Application No.: 10/812,447

Docket No.: JCLA10877

### Discussion objection to the Drawings

### Annotated Marked-up drawing

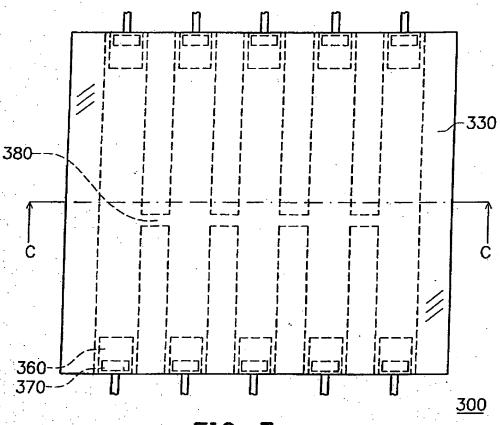
The drawings are objected to as failing to comply with 37 CFR 1.84(p)(5) because they include the following reference character not mentioned in the description: figure 8, item 304.

In response thereto, applicants correct item 304 in Fig.8 to be "item 340" because the reference numeral 304 is a typographical error of the reference numeral 340.
